DRAINAGE INFORMATION SHEET

RE: DRAINAGE PLAN SUBMITTAL OF THE RIO GRANDE ZOO GREENHOUSE
RECEIVED JUNE 7, 1989 (K-13/D27)

DRAINAGE PLAN
RIO GRANDE ZOO
GREEN HOUSE

RIO GRANDE ZOO GREENHOUSE
CITY OF ALBUQUERQUE

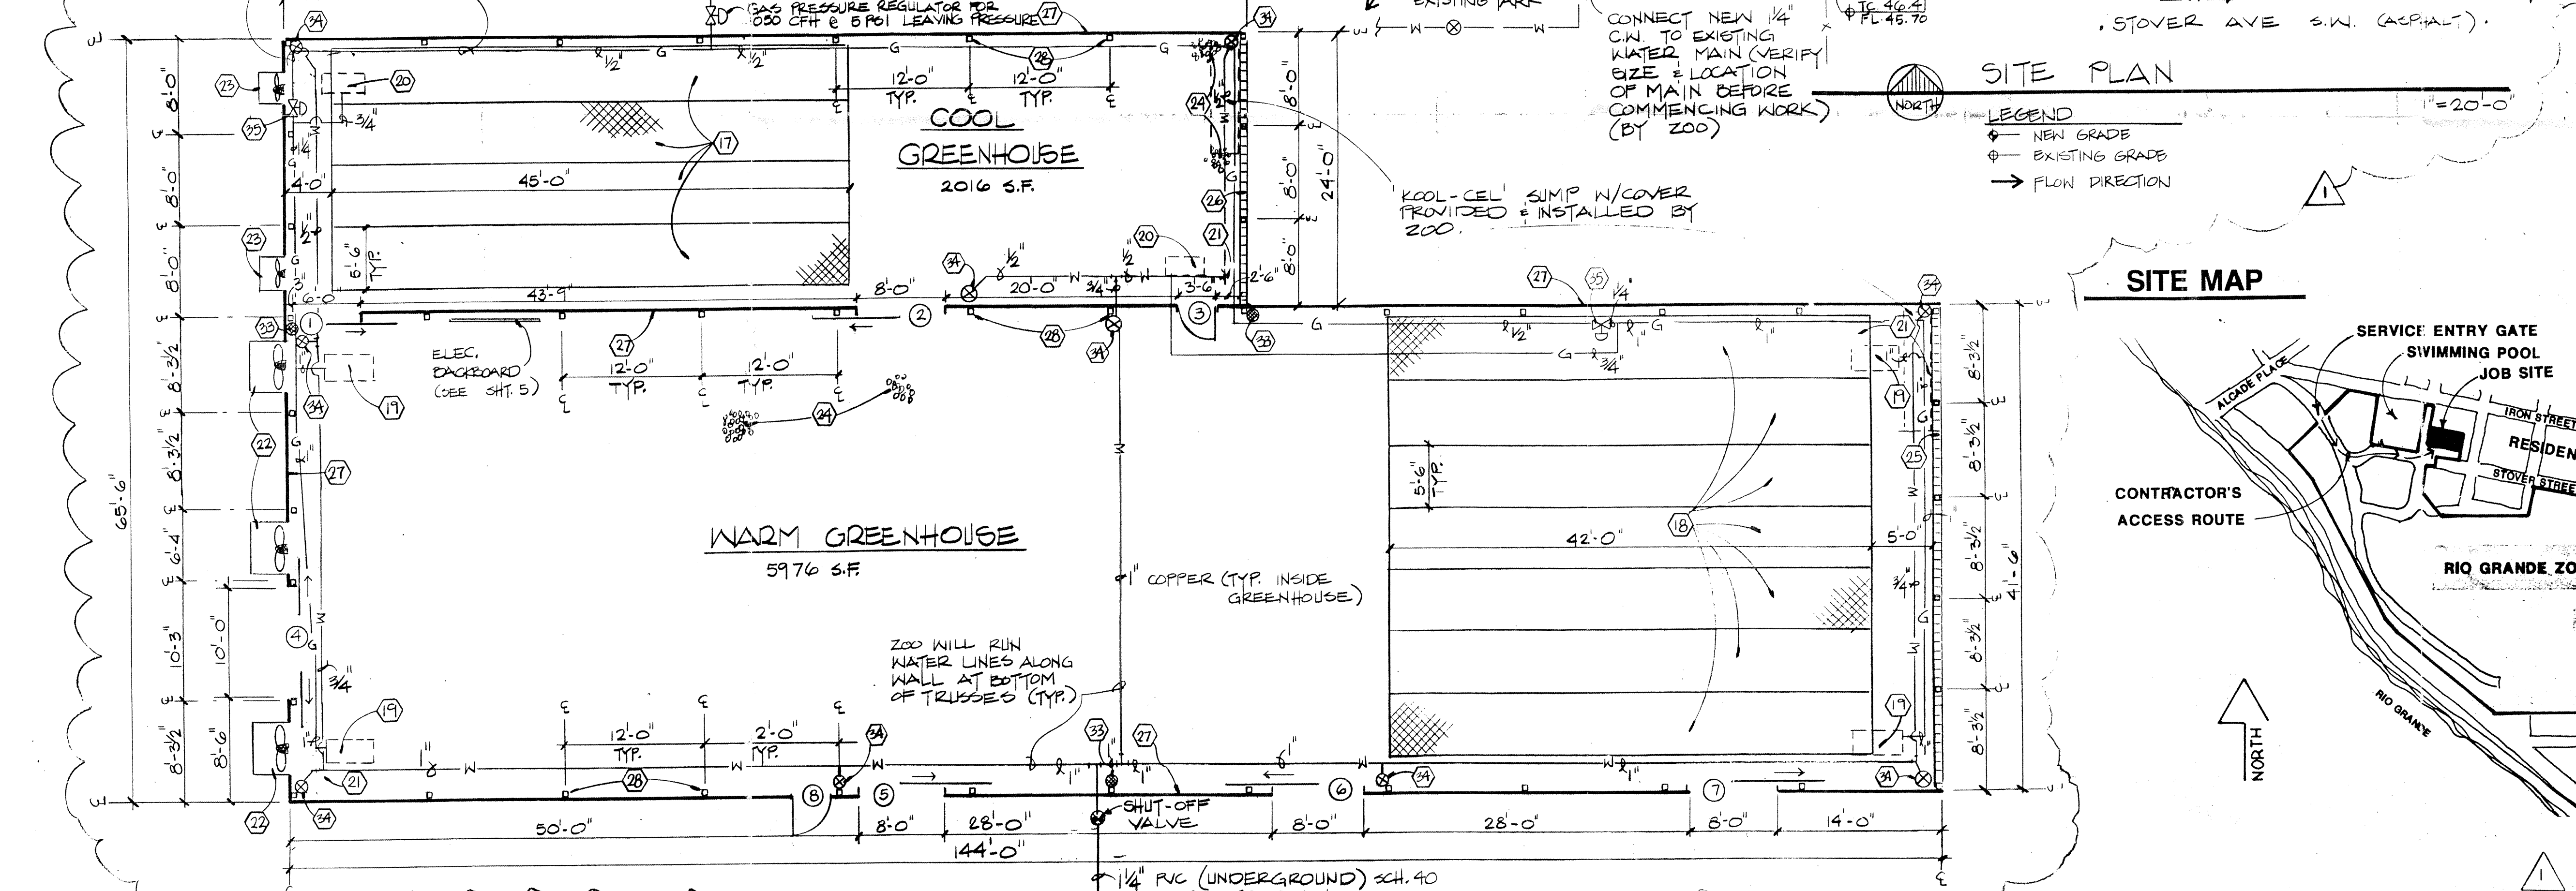
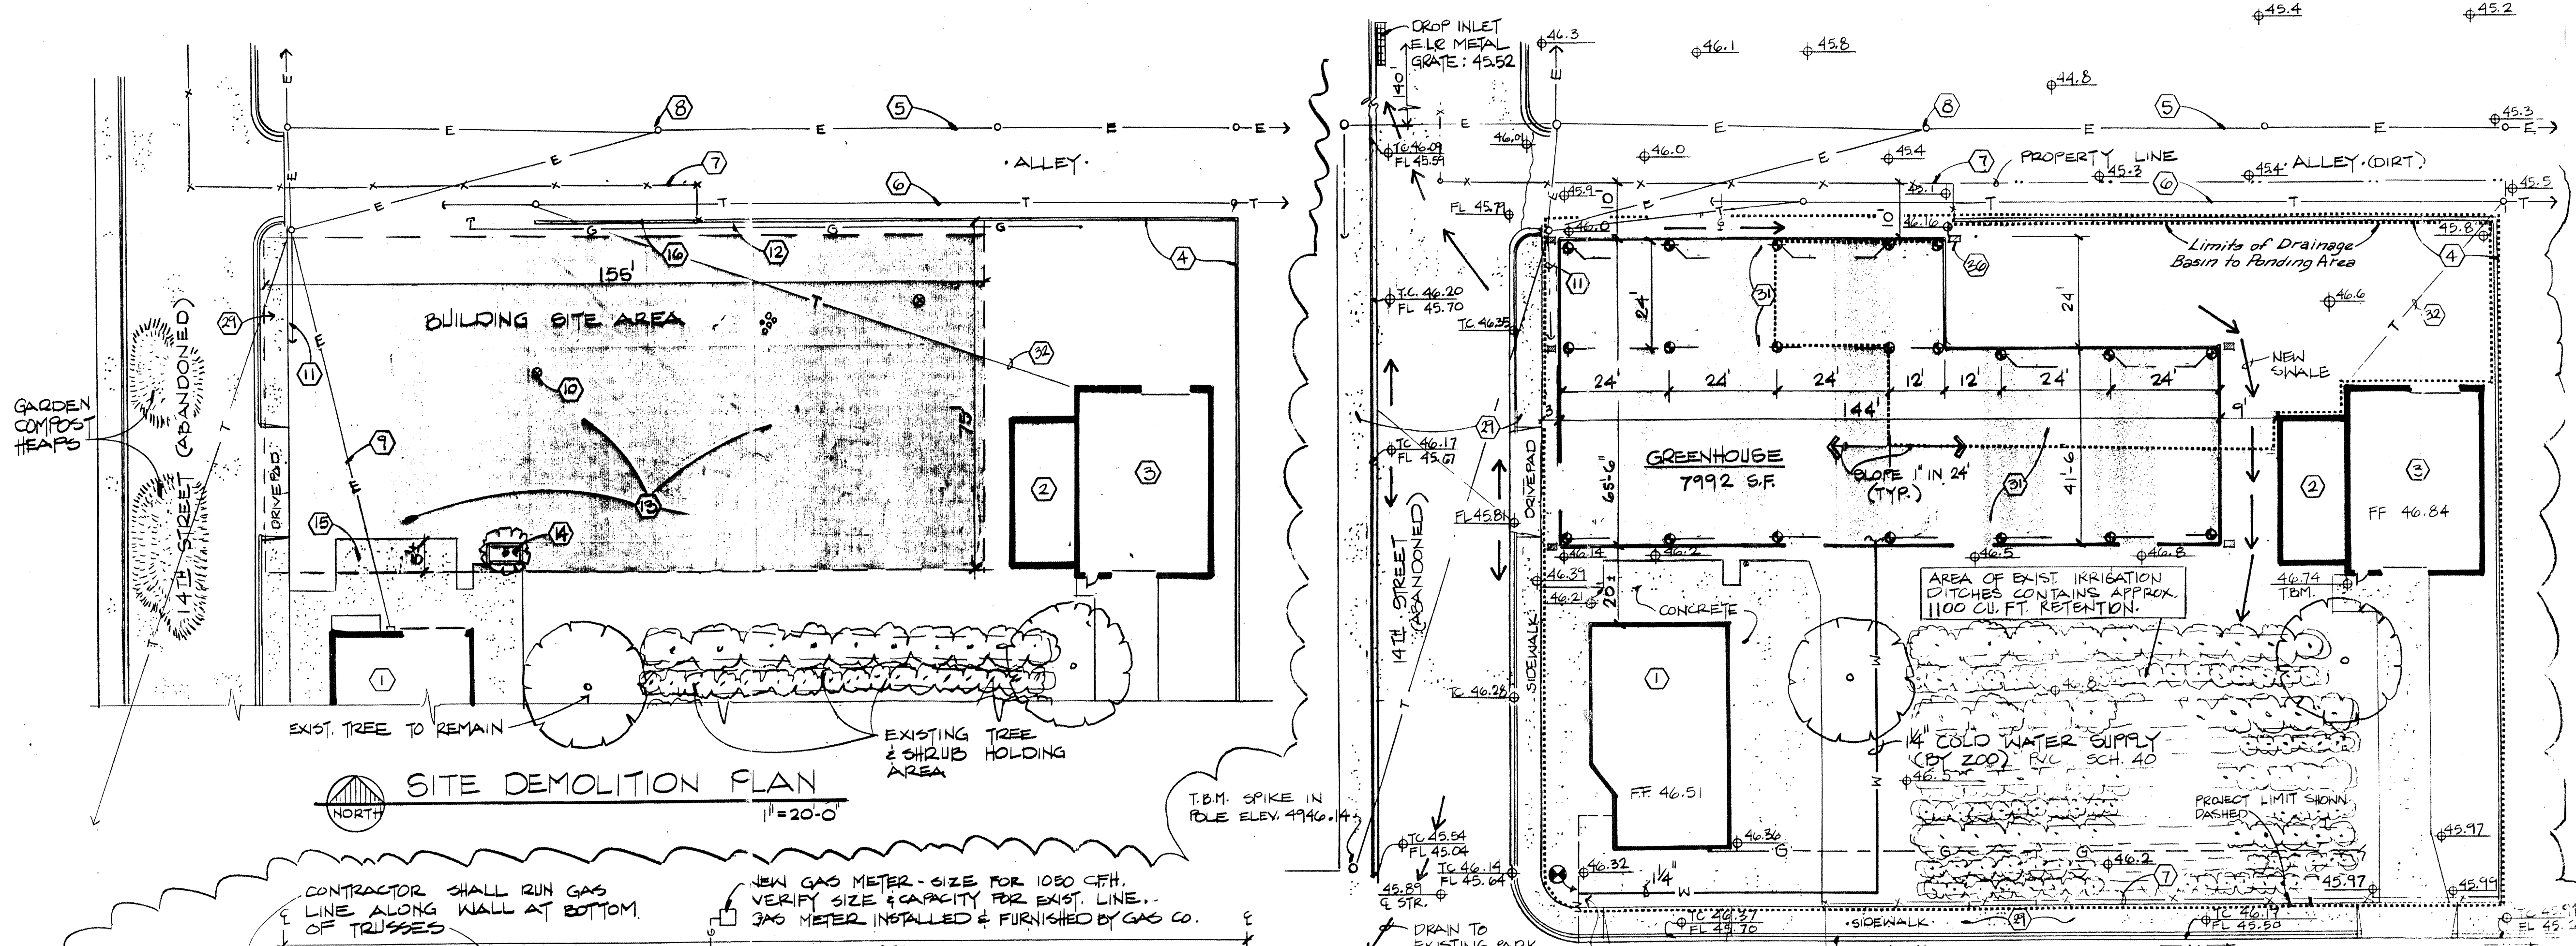
The referenced plan with a revision date of June 7, 1989, is approved for Building Permit.

Please attach a copy of this plan to the construction sets prior to sign-off by Hydrology. Please advise the contractor that a final inspection will be required prior to release of the Certificate of Occupancy.
